ADDENDUM No. 5 - February 3, 2016

Nelson Place Elementary School

CLIENT INFORMATION:
Worcester Public Schools
City of Worcester
Massachusetts, 01605

B / A6.10 **Composite Deck to Fire Wall Detail**

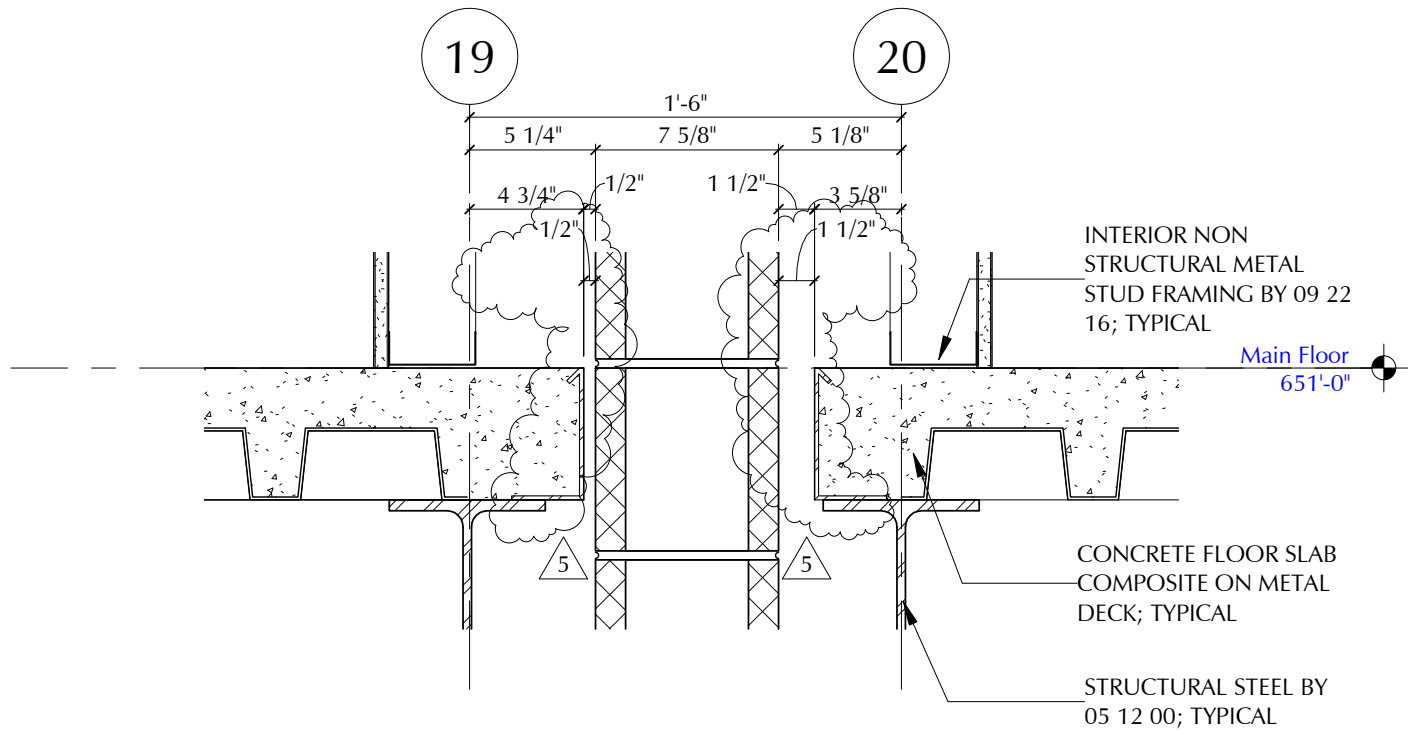
A. Revised drawing details B and wall section 42, see sketch ADD5 A-002.

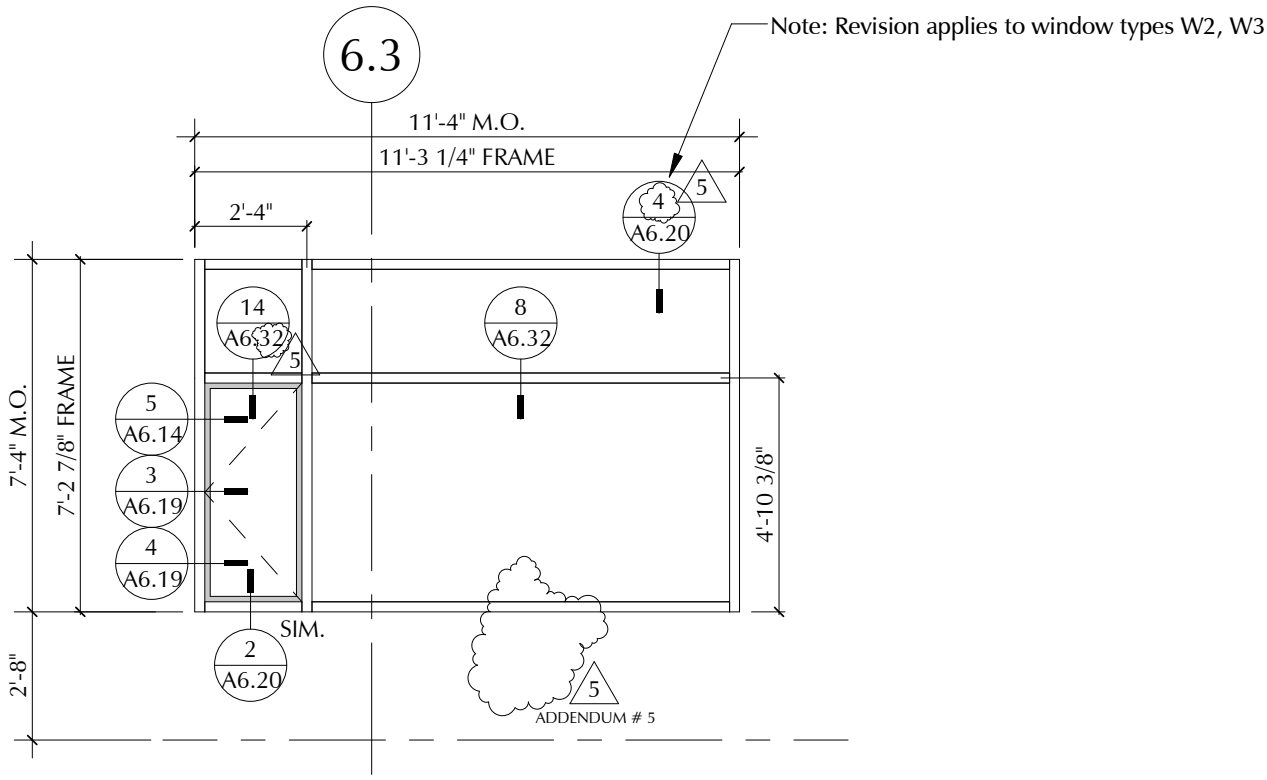
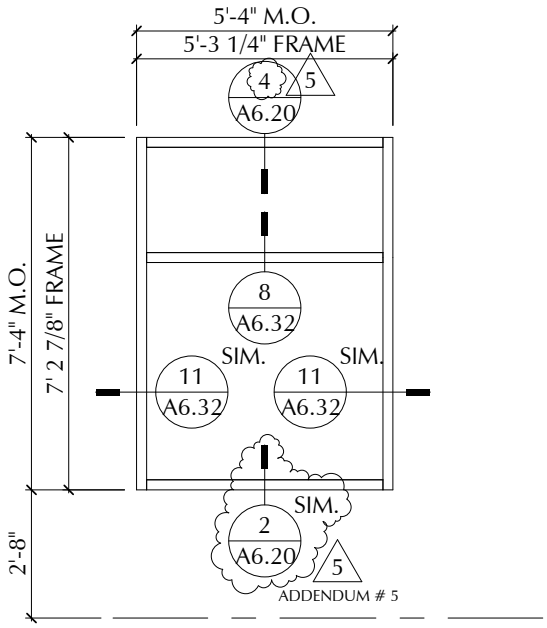
A. Revised drawing references to W1 and W4, see sketch ADD5 A-004

B. Revised drawing references to W2 and W3, see sketch ADD5 A-004 for similar reference revisions.

Section @ Stair 4 E-W ADD5 A-005

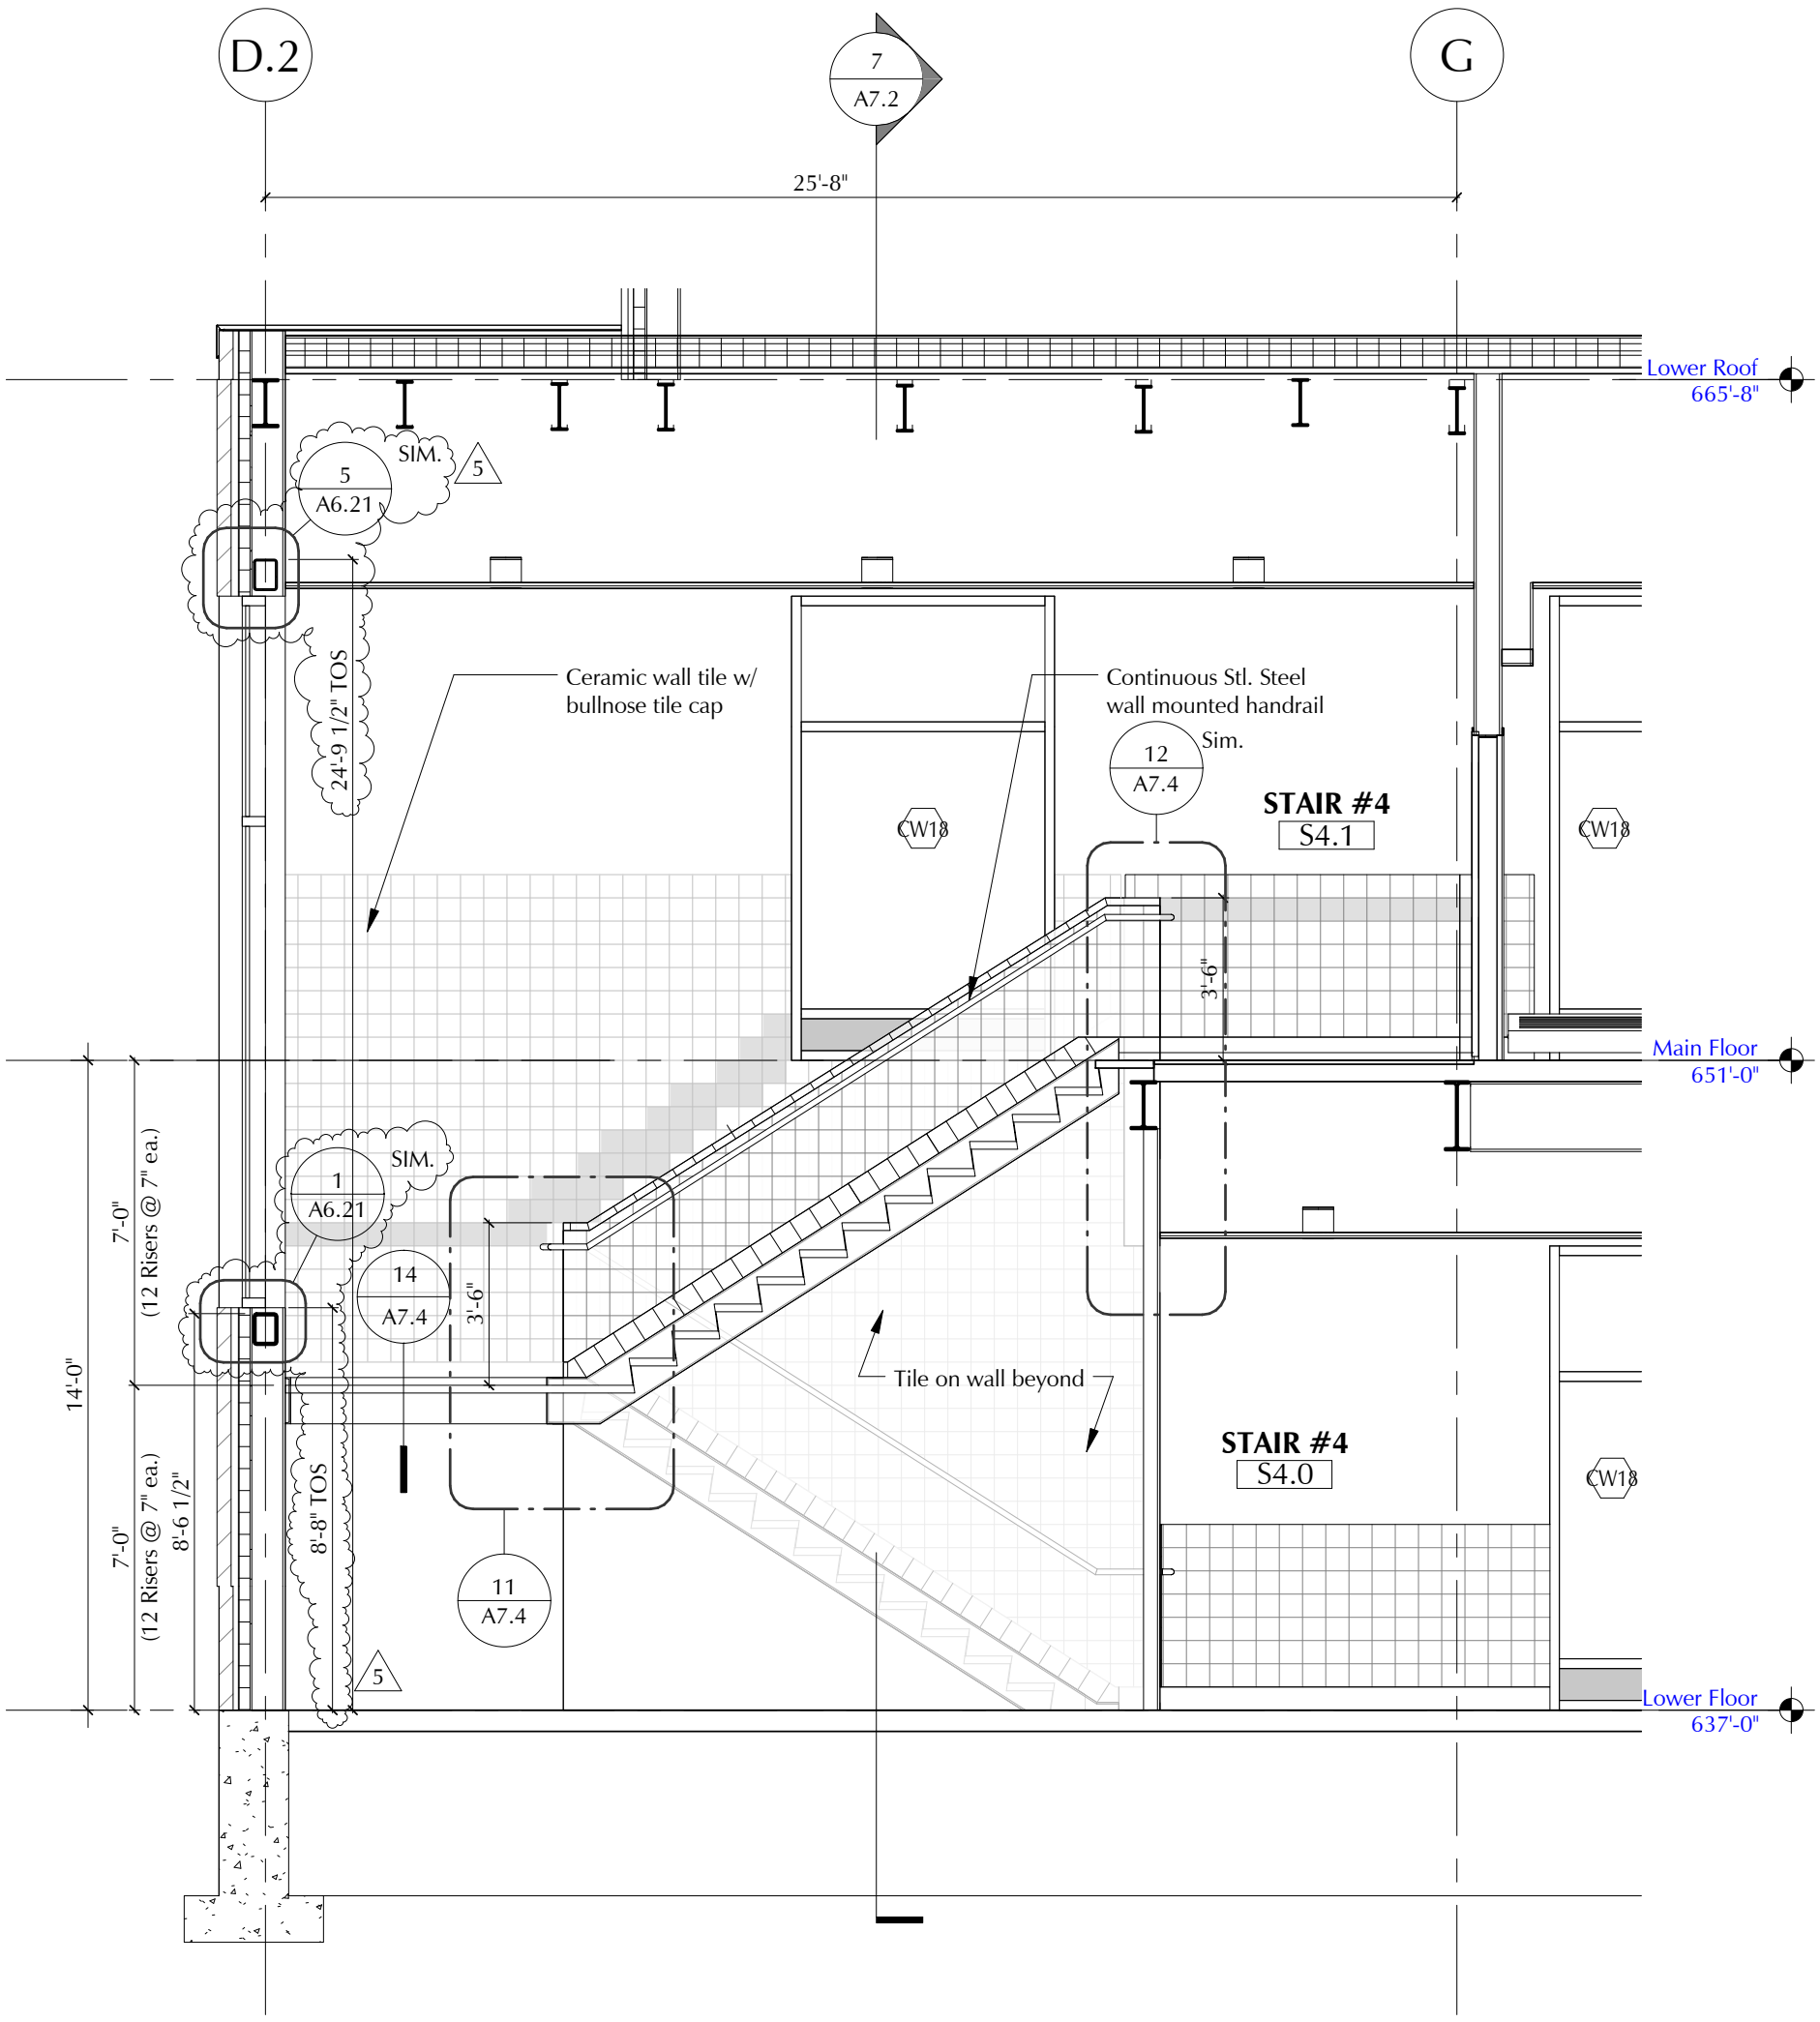
A. Add detail references, graphic representation to steel structure as shown by structural and TOS dimensions, see sketch ADD5 A-005.

Masonry Type B1 Clarification by Control Joints Diagram

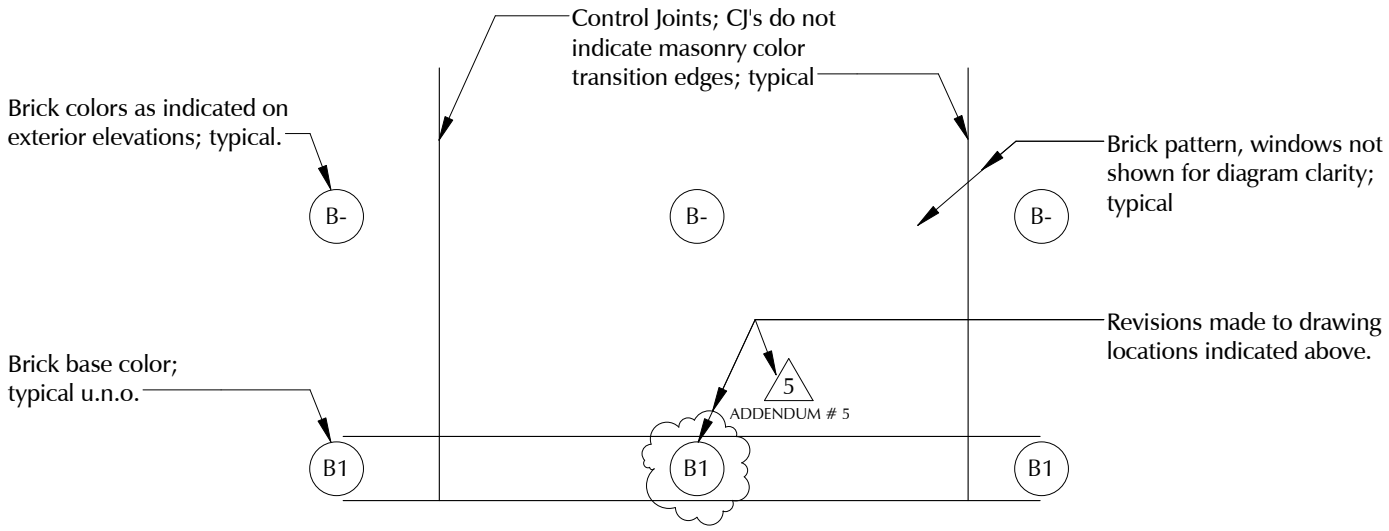
A. Add Brick Masonry Veneer Type tag to drawing 1 and 6, see sketch ADD5 A-012

A. Add Brick Masonry Veneer Type tag to drawing 3 and 6, see sketch ADD5 A-012

15 / A8.5 Intermediate Music East Int. Elevation C182

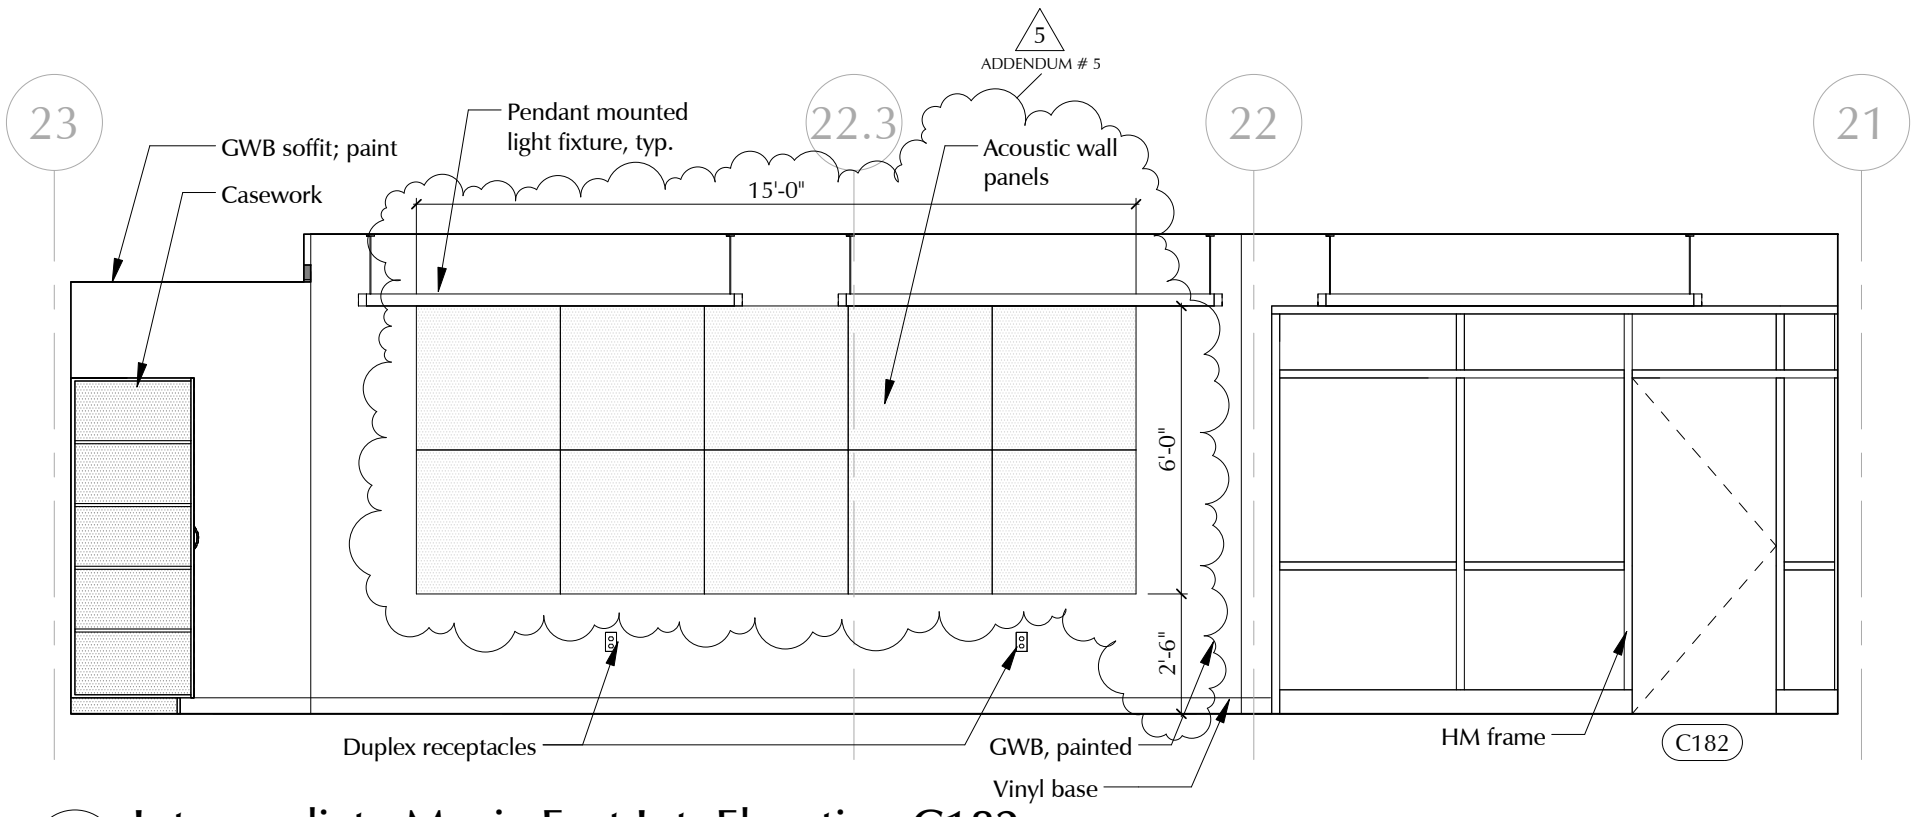
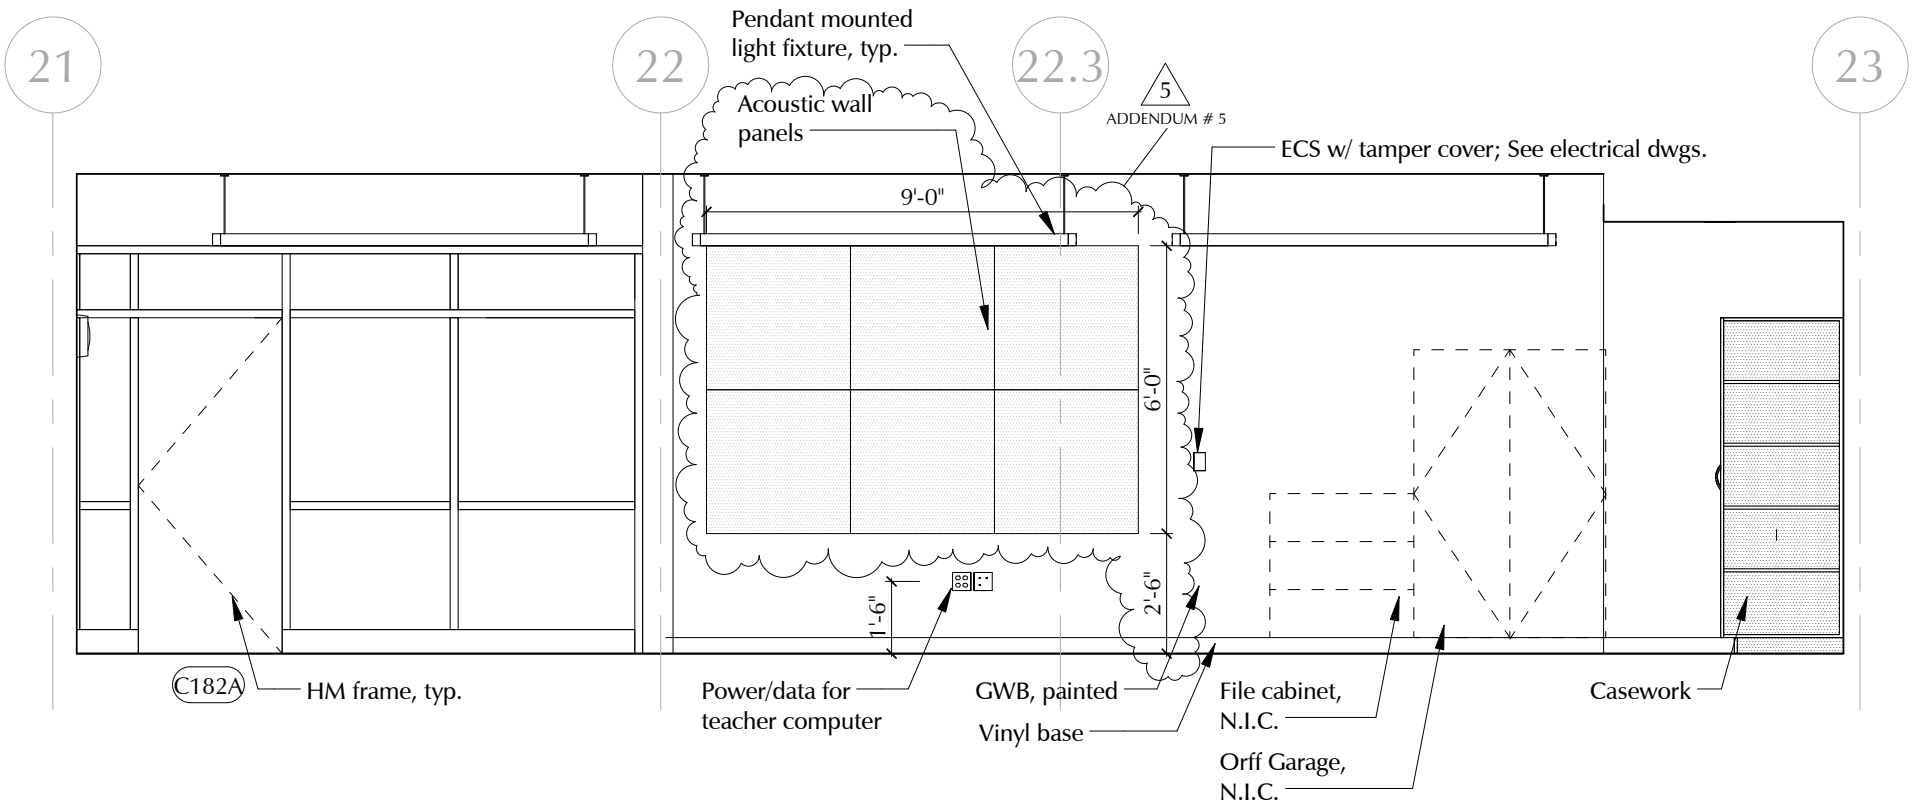
A. At Corridor C170 and C180: Change note: "(35 double tier lockers)" to "(34 double tier lockers)".
B. Add Acoustic Panels to Music C182. See Sketch ADD5 A-015.

9 / A8.5 Primary Music West Int. Elevation A226

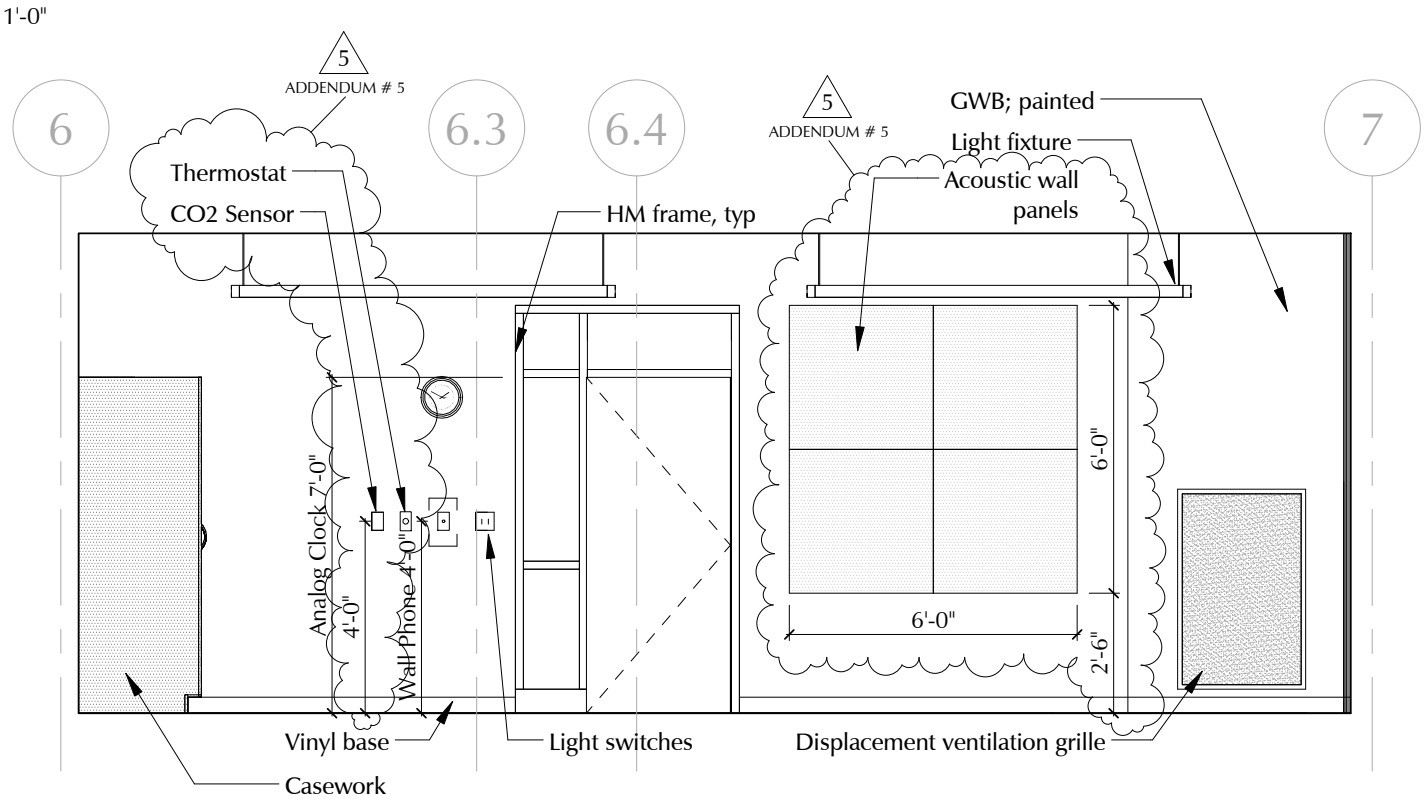
A. Add Acoustic Panels to Music A226. See Sketch ADD5 A-015.
